Access Compliance Report Public Rights-of-Way (Curb Ramps)

Main Street: YORBA_LINDA_BLV		Cross Street: N/A		Location:	SW
ADA ID: RPAT210923080815	Ramp Type: Type 4 - Parallel	Initial Pass/Fail: Fail	Overall Compliance: No	Severity Score:	15

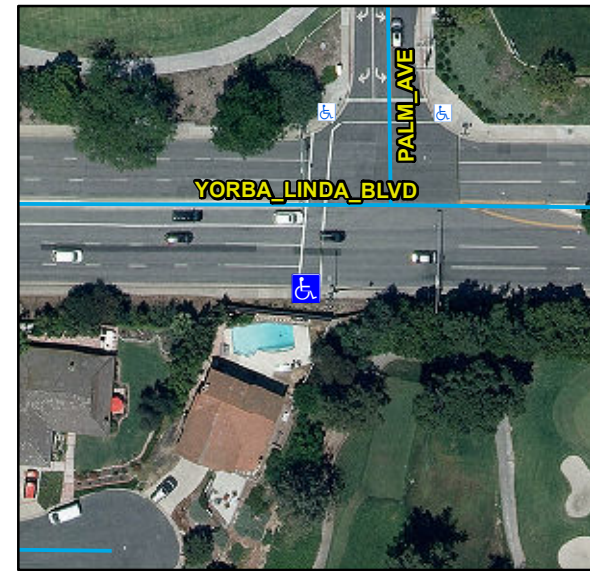
Compliance	Description	Data	Compliance	Description	Data
N/A	Ramp Length LT (in)	67	N/A	Ramp Length RT (in)	89
Yes	Ramp Width LT (in)	59	Yes	Ramp Width RT (in)	59
Yes	Ramp Run Slope LT (%)	2	No	Ramp Run Slope RT (%)	10.1
Yes	Ramp Cross Slope LT (%)	0.3	Yes	Ramp Cross Slope RT (%)	0.7
N/A	Landing Present	N/A	N/A	DWS Provided	N/A
N/A	Landing Length (in)	N/A	N/A	DWS Contrast	N/A
N/A	Landing Width (in)	N/A	N/A	DWS Length (in)	N/A
N/A	Landing Run Slope (%)	N/A	N/A	DWS Full Width	N/A
N/A	Landing Cross Slope (%)	N/A		DWS Offset Type	N/A
N/A	Landing Movement Obstructed?	N/A	N/A	DWS Offset Left (in)	N/A
	Landing Movement Type	N/A	N/A	DWS Offset Right (in)	N/A
N/A	Landing Shared	N/A			
N/A	Clear Space	N/A			
N/A	Clear Space To Crosswalk (in)	N/A			
N/A	Marked Crosswalk 1	Yes	N/A	Marked Crosswalk 2	N/A
	Crossing 1 Direction	N		Crossing 2 Direction	N/A
	Marked Crosswalk 1 Width (in)	120		Marked Crosswalk 2 Width (in)	N/A

Remove & Replace Entire Ramp.

R304.3.2, STD 1115
